Ref: 17165-Waitara-Access Report R3-201217

**WAITARA PUBLIC SCHOOL**

**DISABILITY DISCRIMINATION ACT (DDA) COMPLIANCE REPORT  
FINAL DA STAGE REVIEW**

**DECEMBER 2017**

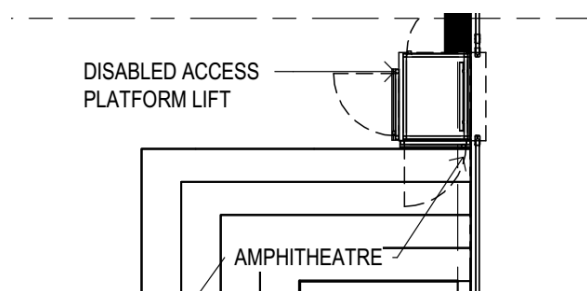
The stage is required to be accessible and it is proposed to be provided with a platform lift.

A platform lift is also proposed for the external amphitheatre.

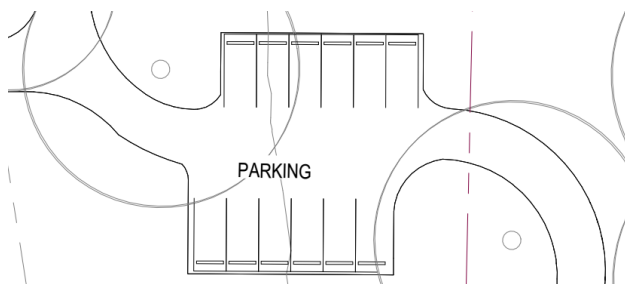
Confirm if the site is proposed to be provided with an accessible carspace. If it is disabled access is required to be provided from the accessible carspace to the proposed building. Note the addition of new carspaces on site will trigger the requirement for an accessible carspace to be provided.

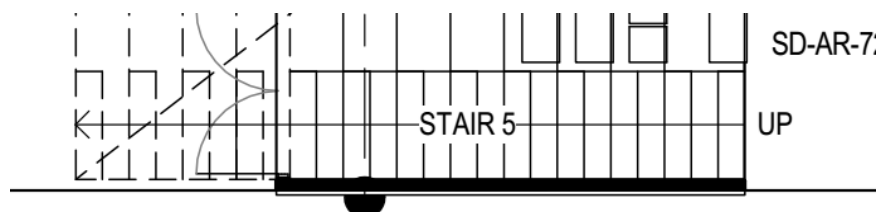
The lack of a second handrail to the amphitheatre stair will be noted as a non compliance on the Section 109R Crown Works Certificate.

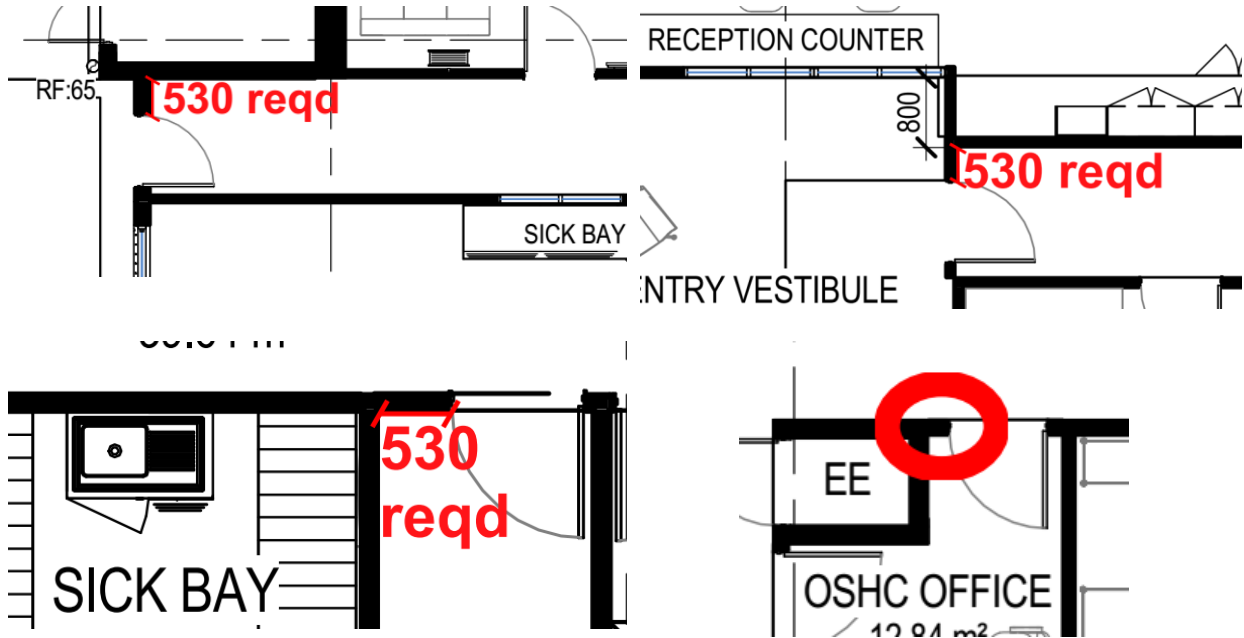
The circulation spaces to the following doorways is required to be modified during design development to comply with the circulation space requirements of AS1428.1 2009.

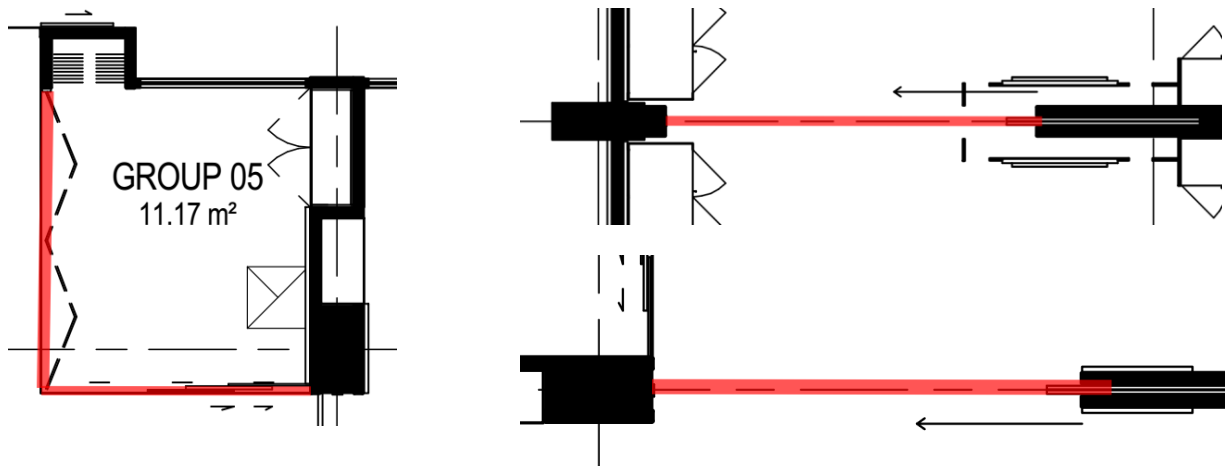
The compliance of the following sliding doorways to the circulation space requirements of AS1428.1 2009 is required to be confirmed during design development.

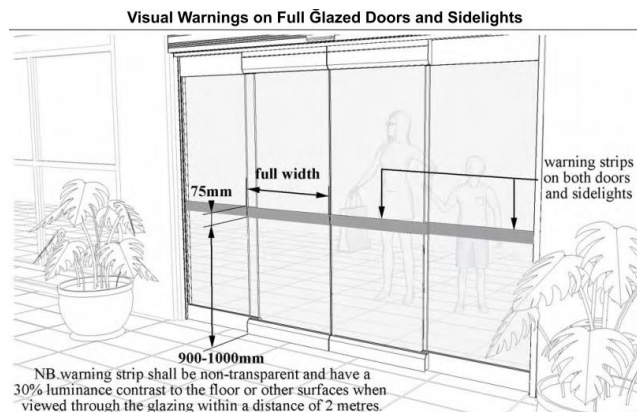
The lack of compliant wheelchair seating spaces to the amphitheatre will be noted as a non compliance on the Section 109R Crown Works Certificate.
